8 February 2021

**Re: Independent Flooding Assessment  
SSD 10416: Powerhouse Parramatta  
Review of Flooding Aspects**

To	WMA DPIE	4 February 2021
Copies	Tom Kennedy	Reference number 273467
From	ARUP	File reference Tech Note 3001
Subject	Powerhouse Parramatta – Undercroft Loss Factors and Afflux with Fixed Screen

**Figure 1: Alignment of Assumed Fixed Grille**

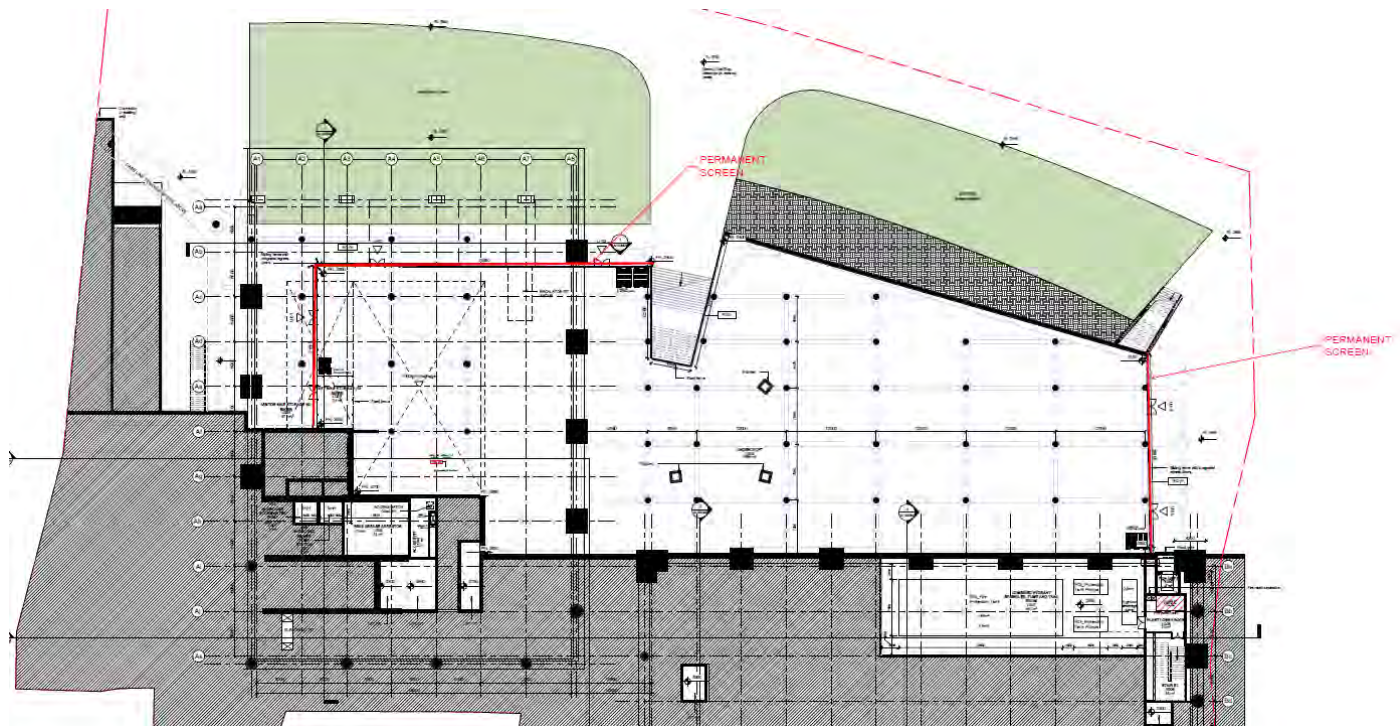
This was represented in the TUFLOW model using rows of 2d\_lfcshp (i.e. FLC) cells along the alignment of the proposed screen (see Figure 1 below).

A form loss coefficient was used to represent the fixed grille. This is a factor used to represent turbulence due to a partial obstruction. A form loss coefficient of 0.4 was used based on an assumed ratio of bar width to bar spacing of approximately 0.20 to 0.25 (i.e. 20% to 25%) depending on the profile of the bars. See Section 2.6 for examples of fencing with similar ratios.

As well, a 25% blockage factor was included to represent possible debris build-up on the screens which could account for a 0.5m deep debris mat in 3.3m deep water (undercroft level of 3.5mAHD and 1% AEP flood level of 6.8mAHD) plus another 10% debris build-up on submerged bars.

Figure A2: FLC values used for representation of piles / columns in undercroft (East Bldg)

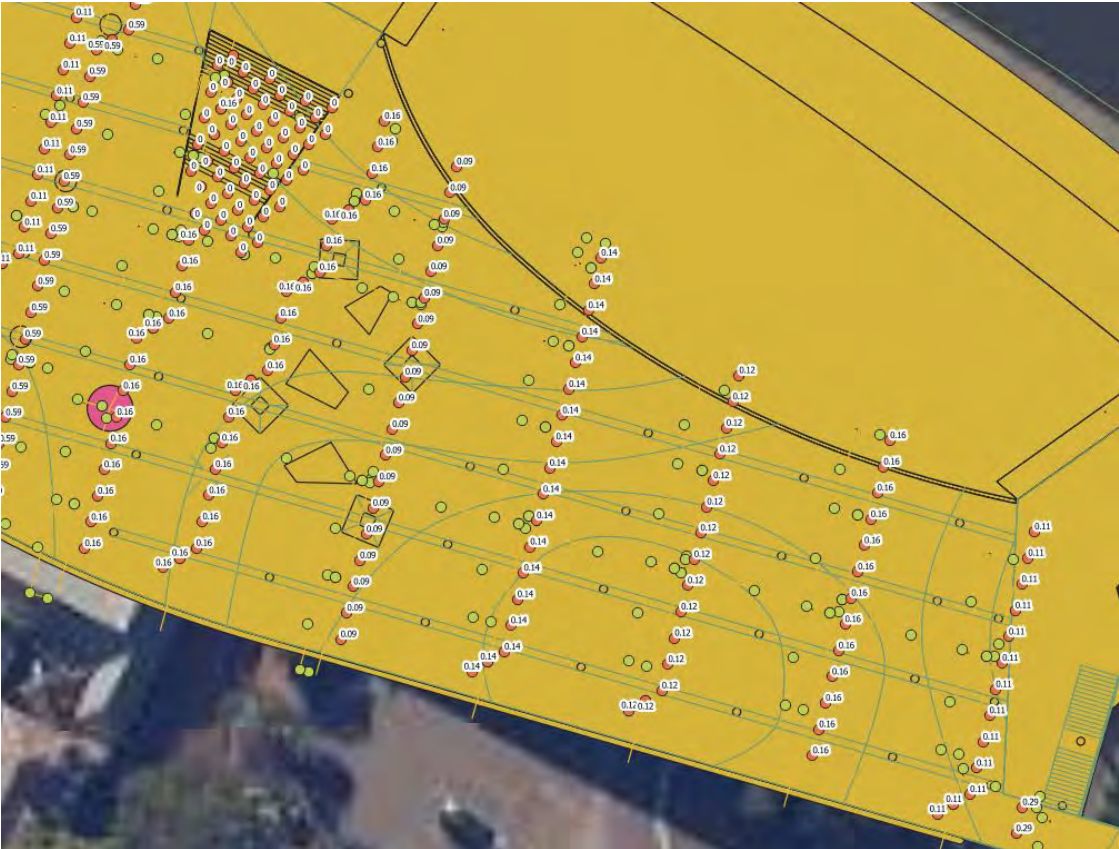
The proposed structural columns have been treated like a set of bridge piers and represented the losses accordingly using a distributed loss along the line of the columns (using a J value and appropriate k value).

The k values were derived from Figure 4.10 of Guide to Bridge Technology Part 8: Hydraulic Design of Waterway Structures (AustRoads, 2018).

J values (i.e. the ratio of pile with to pile spacings) were derived from the concept engineering drawings of the undercroft area (lower ground level).

The k values were then represented in the TUFLOW model at the nearest appropriate cell side using 2d\_lfcshp files.

Post-development - River Flood  
Fixed Grill, FLC=0.4 & BLKG=25%  
Afflux  
1% AEP (540 min)

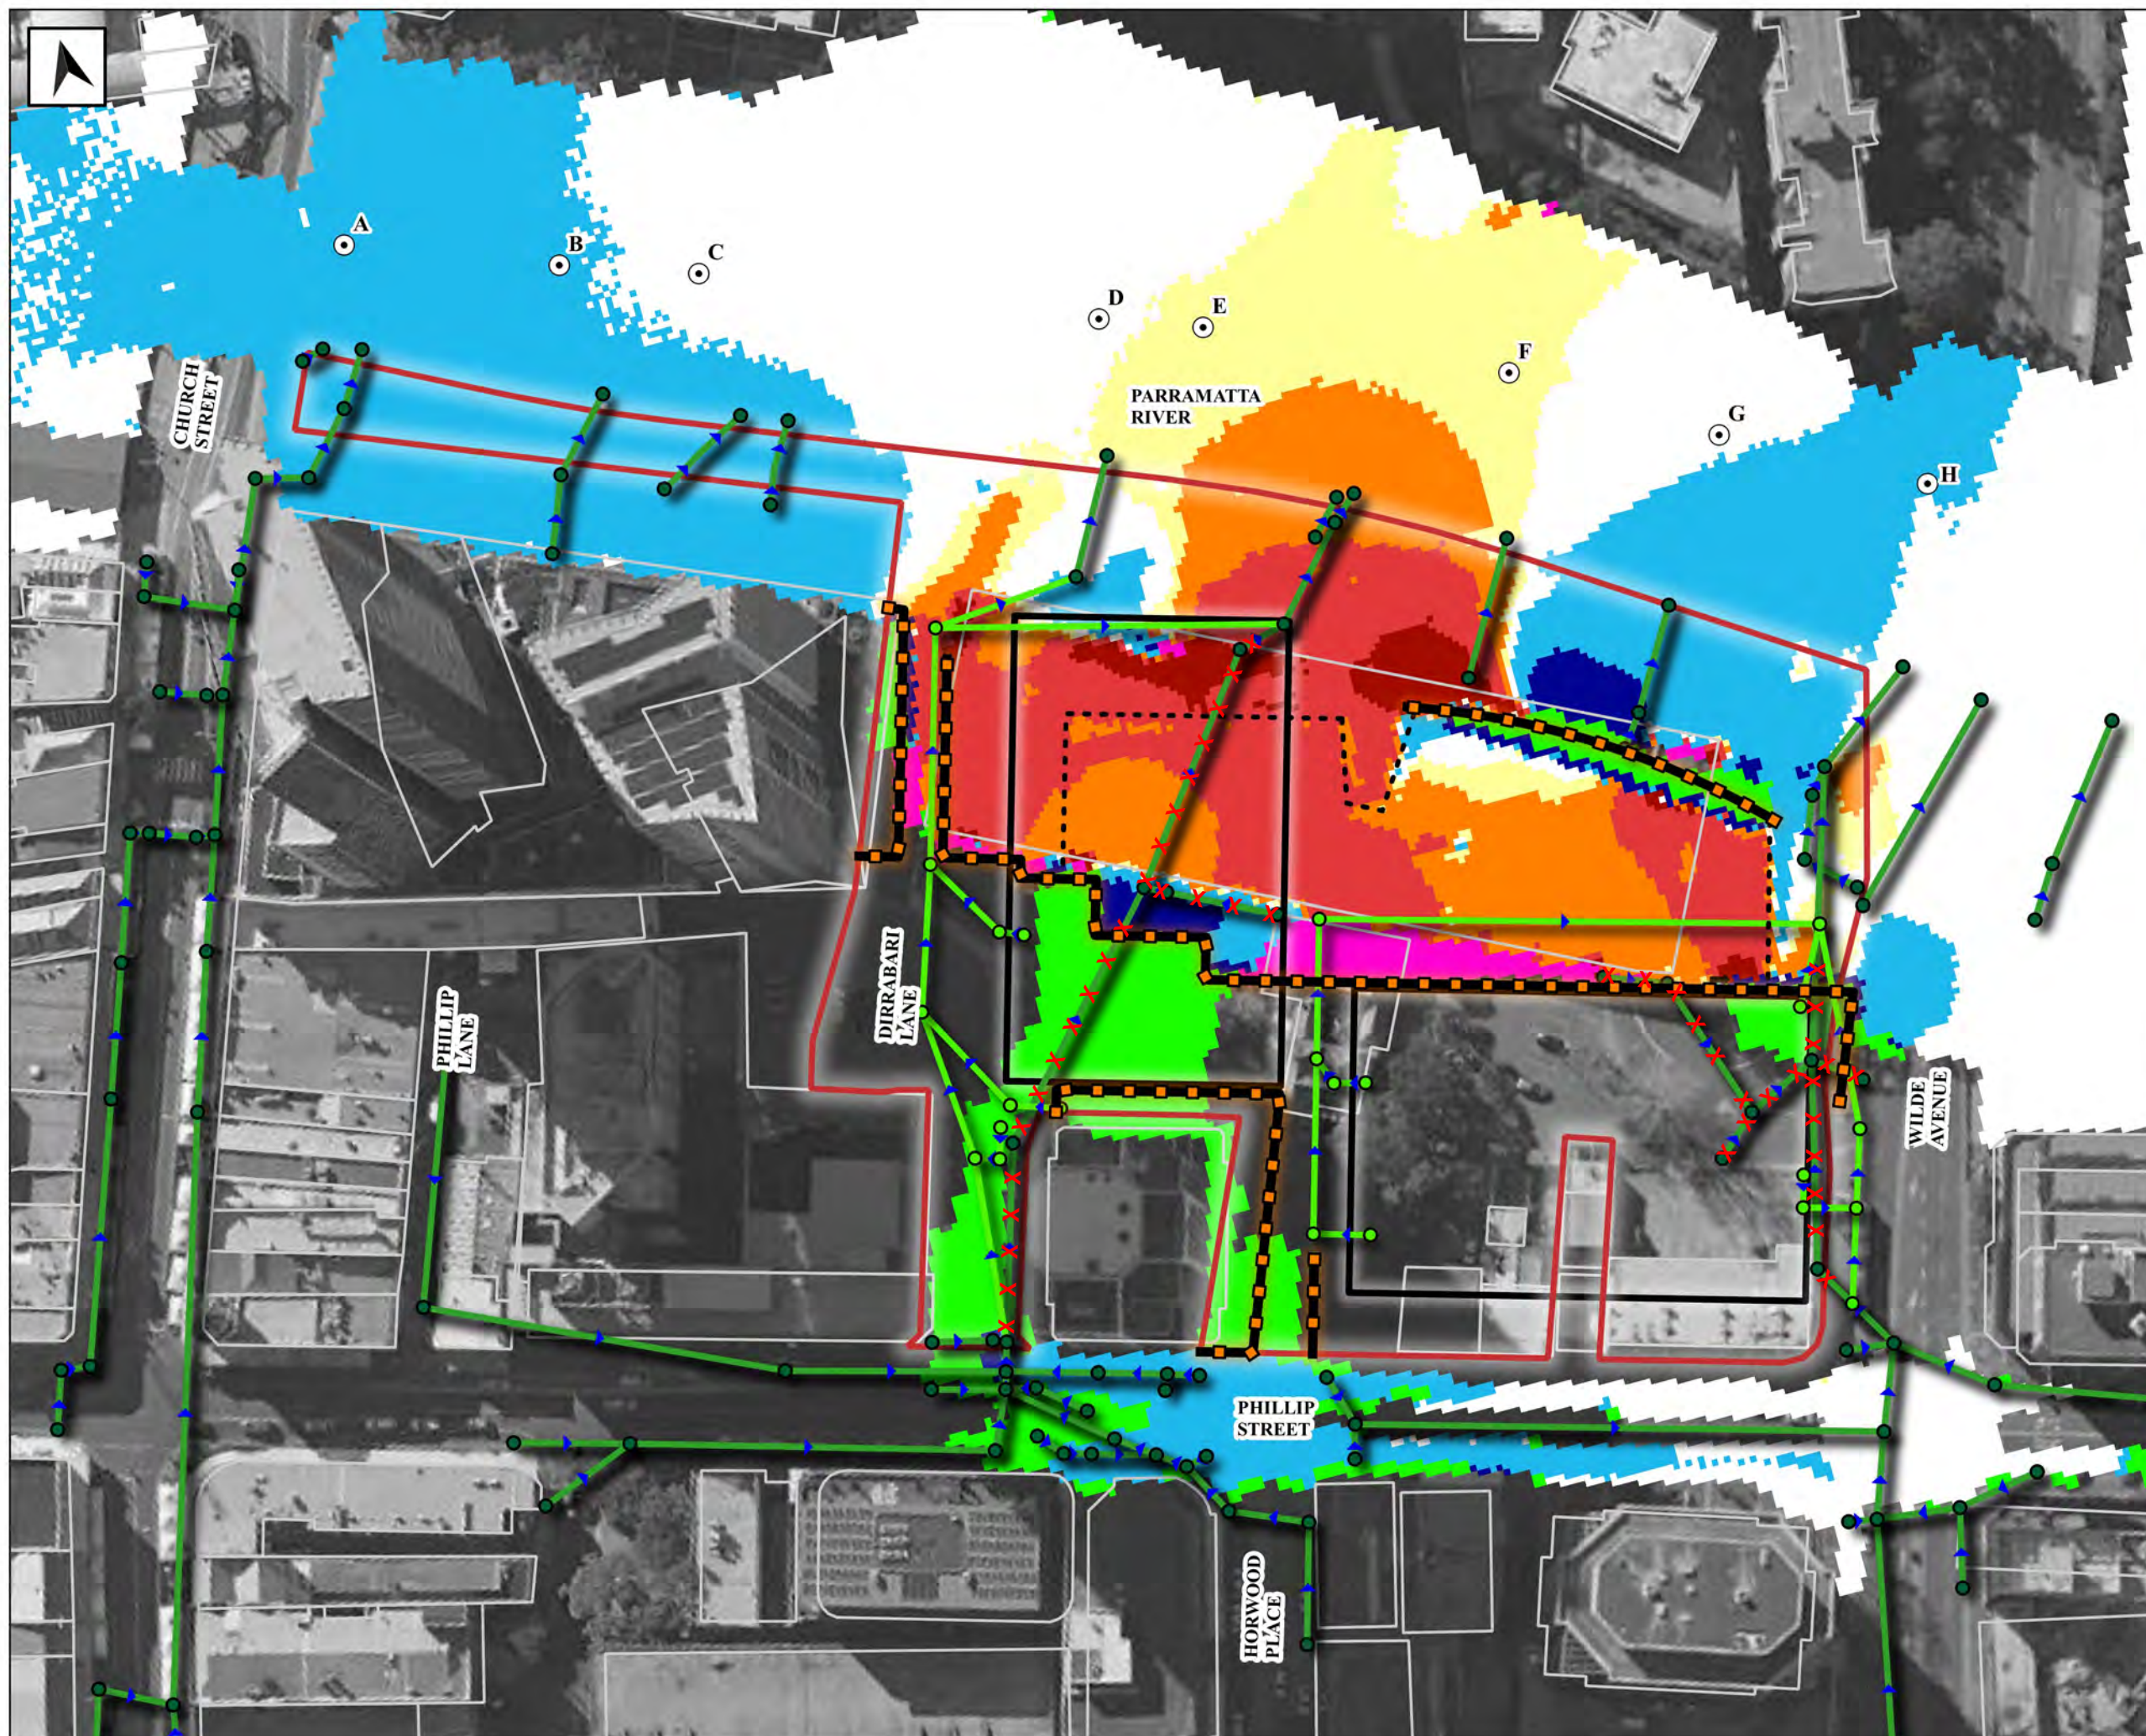
The flood afflux maps for this fixed grille scenario are presented as Drawings 1 and 4 for the 1% AEP and 5% AEP flood events respectively. The afflux was derived by comparing the flood levels with the fixed grille to the base case assuming that all cars are removed from the current car park prior to the flood event (i.e. the same base case as assumed in the EIS and RTS assessments).

This afflux map indicates that there would be afflux less than 10mm on all private property for this scenario with the following exceptions:

- 330 Church Street (the neighbouring Meriton apartments) – note that the potential impact of this afflux to result in inflows into the car park (via an air vent) will be mitigated through a landscaped bund to provide additional immunity to the car park than currently exists. This is discussed in the Response to Submissions Appendix J.
- Riverbank lawn of Museum Gardens Apartments building (fronting Sorrell St) on northern side of river. The areas impacted are lawns on the riverbank and riverbank vegetation as shown in Figure 2 below. The afflux at this location in this scenario are not high and in the order of 10mm to 14mm. The basement car park level of the neighbouring building is at

Post-development - River Flood  
No Grill & Open Undercroft vs Baseline Conditions  
Afflux  
1% AEP (540 min)

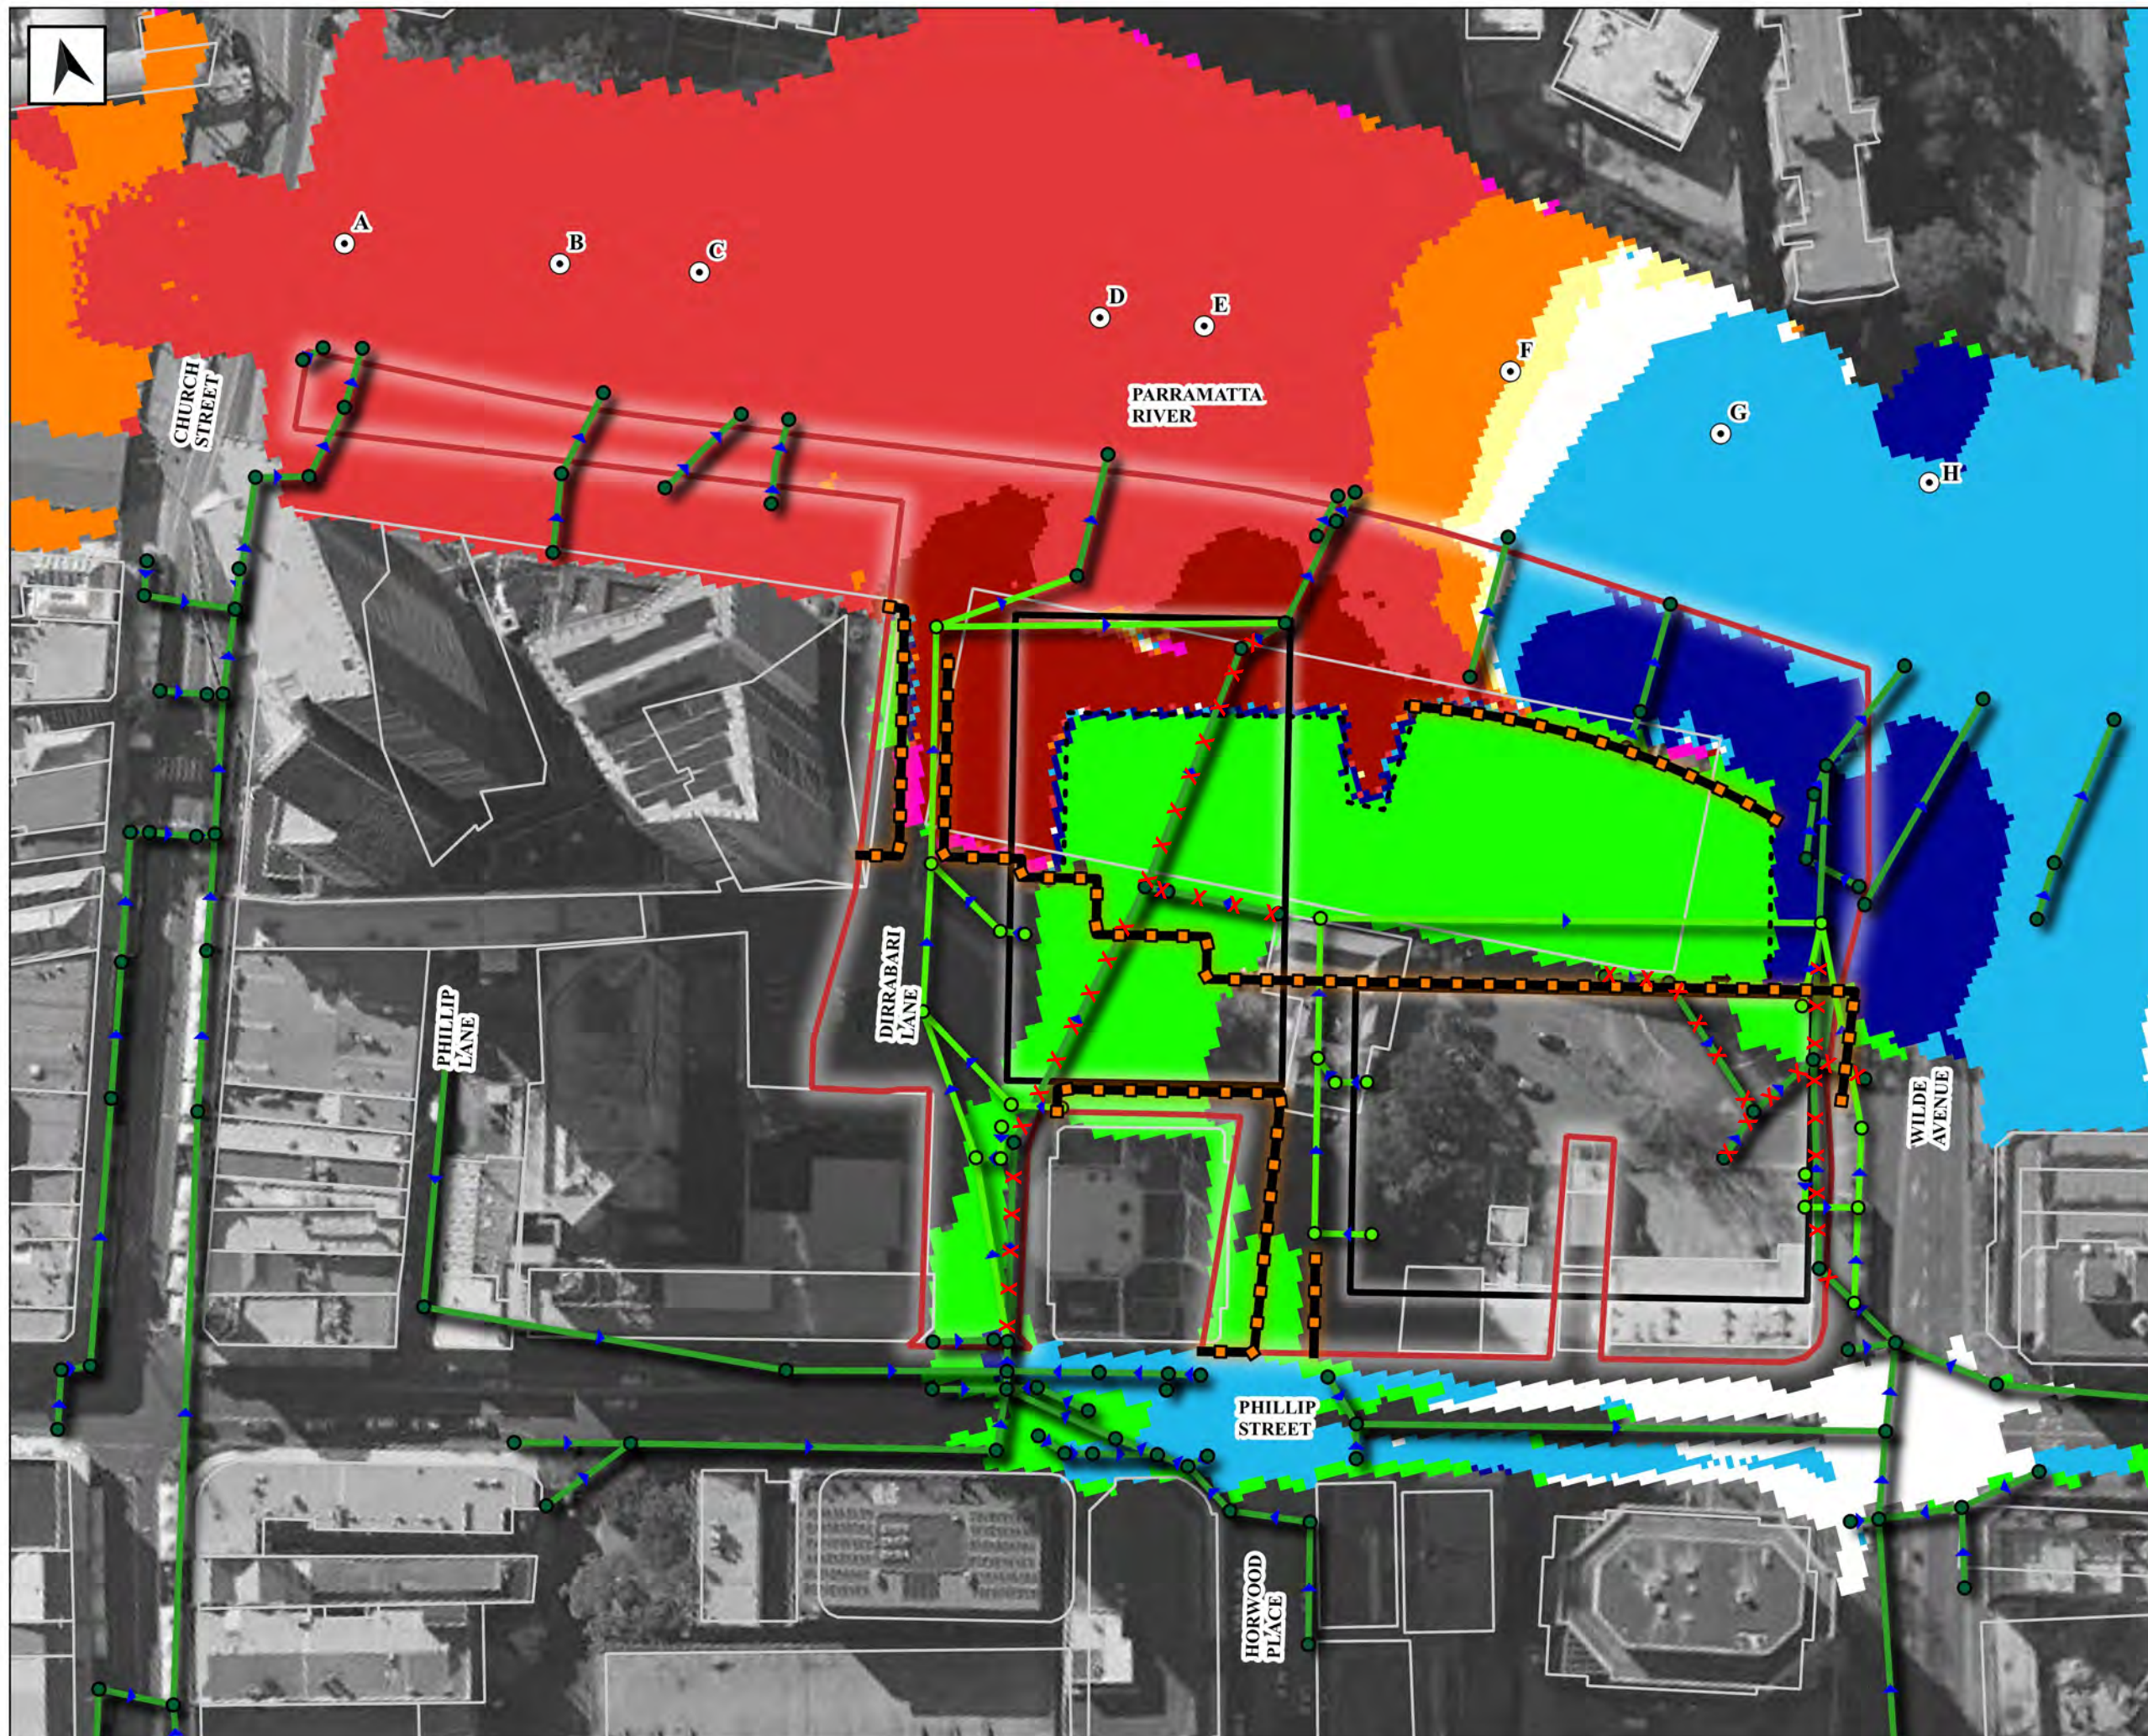
The flood afflux maps for this no grille / screen scenario are presented as Drawings 2 and 5 for the 1% AEP and 5% AEP flood events respectively.

This afflux map indicates that there would be afflux less than 10mm on all private property for this scenario with the following exceptions:

- 330 Church Street (the neighbouring Meriton apartments) – note that the potential impact of this afflux to result in inflows into the car park (via an air vent) will be mitigated through a landscaped bund to provide additional immunity to the car park than currently exists. This is discussed in the Response to Submissions Appendix J.
- Riverbank lawn of Museum Gardens Apartments building (fronting Sorrell St) on northern side of river. The areas impacted are lawns on the riverbank and riverbank vegetation as shown in Figure 3 below. The afflux at this location in this scenario are not high and in the order of 10mm to 12mm. The basement car park level of the neighbouring building is at 7.24mAHD which is 0.3m above the 1% AEP flood level. Hence, there is no impact of this afflux on habitable or utility areas of the properties.
